STATE OF NORTH CAROLINA
DEPARTMENT OF TRANSPORTATION

Subject: **Revised Modification Request for Section 404 Nationwide Permit 23, Section 10 Permit, CAMA Major Development Permit, and Section 401 Water Quality Certification** for proposed widening of the US 17-74-76/NC 133 from the NC 133/SR 1472 Interchange to the US 421/NC 133 Interchange, Brunswick County. Federal Aid Project No. NHS-0017(68); TIP No. R-3601.

References: R-3601 404/401/CAMA permit application dated April 26, 2013
R-3601 Nationwide Permit 23 and 5, issued August 19, 2013 (SAW-2007-03461-010)
R-3601 Major CAMA permit, issued August 2, 2013 (#89-13)
R-3601 401 Water Quality Certification, issued May 16, 2013 (DWR# 13-0472)
R-3601 404/401/CAMA permit modification request dated May 21, 2014

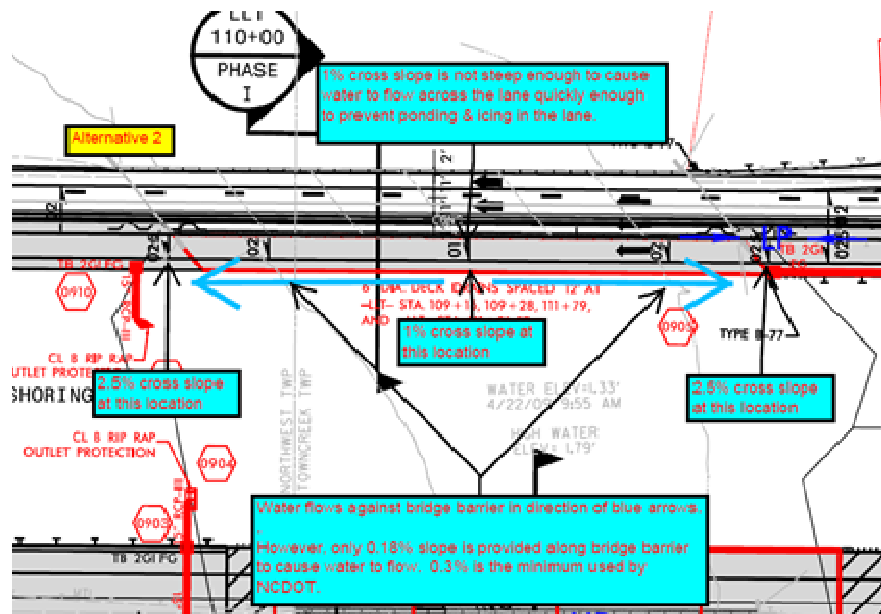
three reasons. 1) A bridge such as 108 that is nominally “flat” has imperfections in the deck that result in low areas where water will pond against the barrier, across the shoulder, and into the lane. 2) It is common for bridges to collect debris such as sand and clumps of grass as high as 6 inches against the bridge barrier that will act as miniature dams that will also trap water and cause ponding. 3) Historically, NCDOT has not constructed bridges without an affirmative means of providing deck drainage; whether it is through deck drains or a prevailing slope to cause water to flow off the ends. Our responsibility to the public requires we provide a well thought out drainage solution with built in redundancy that will function in spite of deck imperfections, debris accumulation, or other unforeseen problems. Providing no deck drains is a solution that requires conditions that are too delicate to be reliable over the long term.

Alternative 2: Provide a variable cross slope on the new lane. This option was proposed by the design build team. This design would create a “false crest” in the middle of the bridge at the 1% cross slope location which would cause water to flow east and west toward the ends of the bridge, where cross slope was gradually increased to 2.5%. The false crest would cause a slope along the bridge barrier of 0.18% falling toward each end of the bridge, which is below NCDOT’s minimum gutter slope of 0.3%, considered constructable and adequate to induce water to flow reliably. Like Alternative 1, Alternative 2 could be an academic solution that worked on paper. However, in practice Alternative 2 is not feasible for reasons 1 and 2 cited for Alternative 1. Ultimately, this solution requires conditions that are too delicate to be reliable over the long term. Furthermore, the area of 1% cross slope in the middle of the bridge is not steep enough to cause water to move across the lane toward the bridge barrier quickly enough to prevent ponding. Said another way, the water depth as it sheet flowed across the 1% section would be deep enough to cause hydroplaning. Additionally, we cannot steepen the cross slope enough to create adequate slope along the barrier rail due to constraints preventing lowering the low chord, bridge structural design constraints, and roadway design criteria governing maximum cross slope on a straight section of road.

PERMIT DRAWING
SHEET 29 OF 44

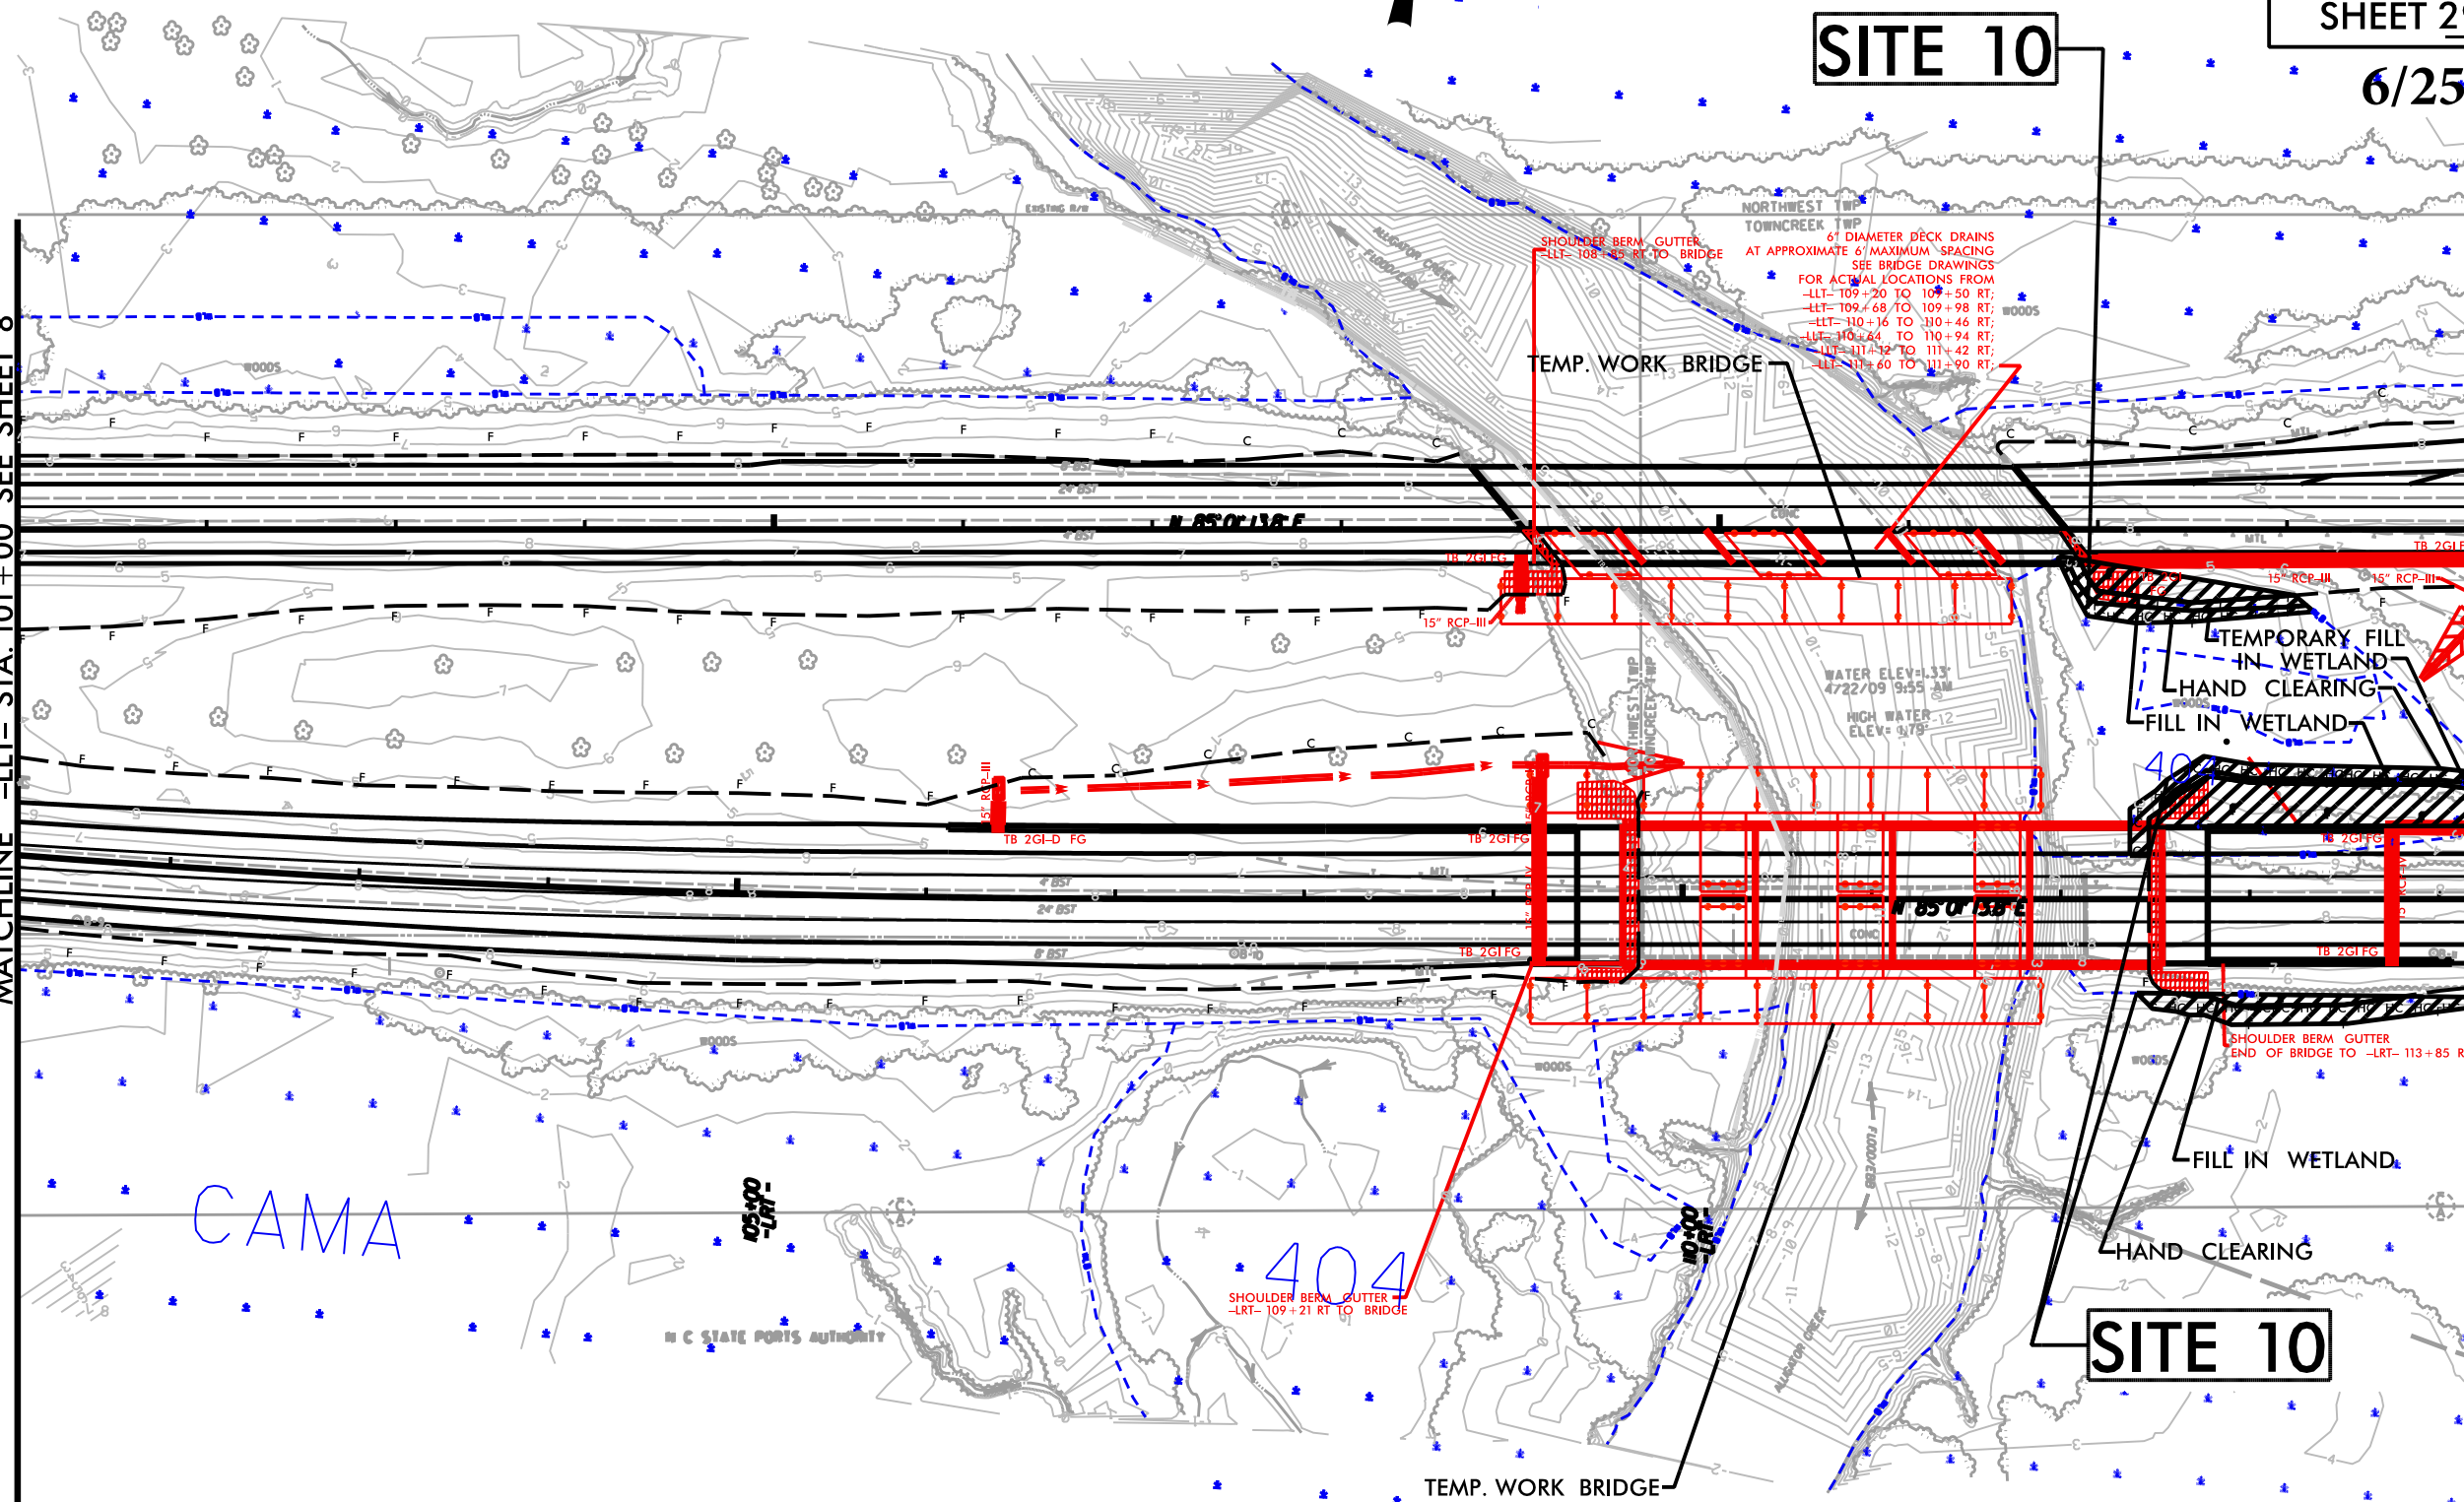
Bridge 108 on southbound US 17 over Alligator Creek will be widened to provide a new traffic lane on the south side of the current alignment. Flat roadway grade line profiles required to meet existing bridge deck elevations on bridge 108 have led to concerns about

potential ponding and accumulation of ice on the bridge deck along the south side barrier. To remedy this situation and improve safety, deck drains will be installed on the south side of the bridge at 6' intervals over a distance of 276 feet. While stormwater from new deck surfaces will be discharged directly to the waterway at Bridge 108, all of the surface drainage at Bridge 107 is to be removed and treated prior to discharge into Alligator Creek, for a net reduction of 3,860 sq. ft. of stormwater draining directly into the creek. Additional justification for deck drains can be found in the attached email exchange with Mason Herndon at NCDWR.

Lastly, geotechnical studies have revealed the need for a surcharge on the east bank of the Alligator Creek for the roadway approach to Bridges 107 and 108. The surcharge involves placement of temporary fill for an interval of time to a specified height in order to consolidate existing underlying soils. The necessary height of the surcharge will lead to an increase in temporary fill in the wetlands between the east and west bound lanes until the surcharge soil is removed. The temporary impact area will replace an area originally designated for hand clearing. The result is an increase of temporary fill in wetland (from 0.01 acre to 0.04 acre total) and a reduction of hand clearing in wetland (from 0.41 acre to total of 0.38 acre).

Utility Permit Drawing
Sheet 2 of 17

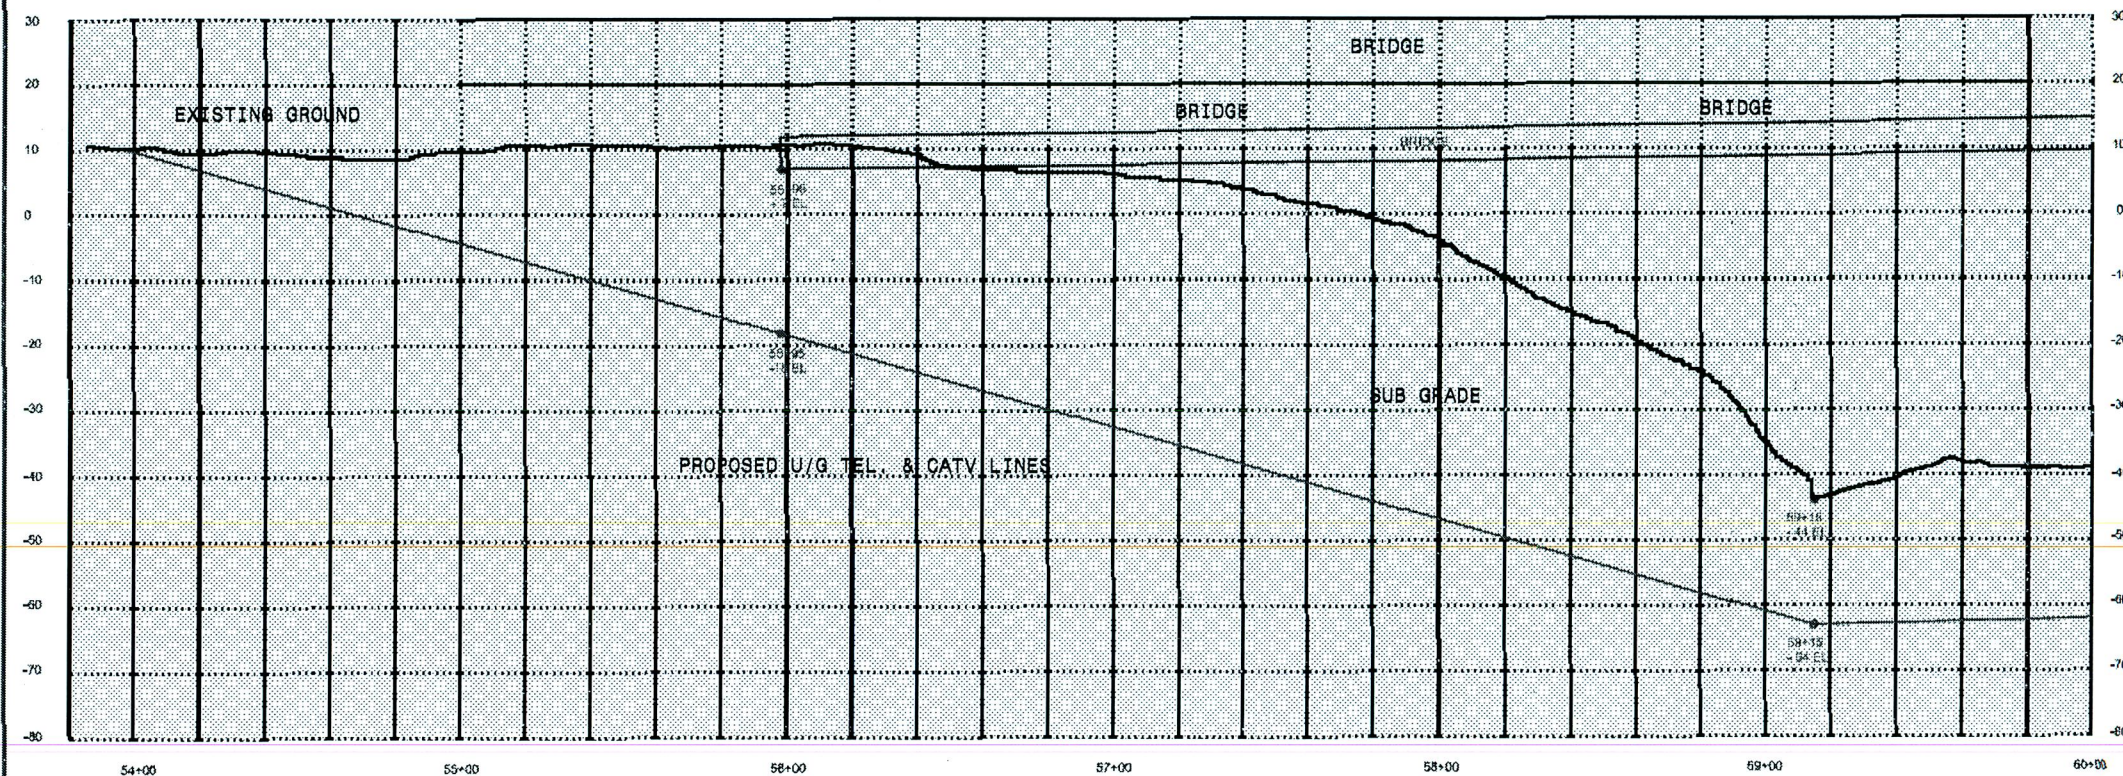
As you are aware, there has been utility activity in jurisdictional areas that was not included in our permit. Therefore, NCDOT is requesting an additional <0.01 of permanent wetland fill for the relocation of an Earthlink line and addition of utility boxes. There has also been a change in the profile of a directional bore of an AT&T underground phone line (no additional impacts), which is reflected on the permit drawings.

SOUNDINGS OF THE BRUNSWICK RIVER WERE RECORDED
AT BOTH BRIDGES, BUT WERE PERFORMED ON THE UPRIVER
SIDE OF THE BRIDGES ONLY, ACTUAL DEPTH AT 60FT OFFSET
FROM BRIDGE IS UNKNOWN THEREFORE IT WILL BE CONTRACTOR'S
RESPONSIBILITY TO RECORD DEPTH AND MAINTAIN
MINIMUM 20FT BELOW EXISTING GRADE ACROSSRIVER,
AND MAINTAIN A MINIMUM DEPTH OF 10FT BELOW SURFACE
INSIDE DELINEATED WETLANDS.
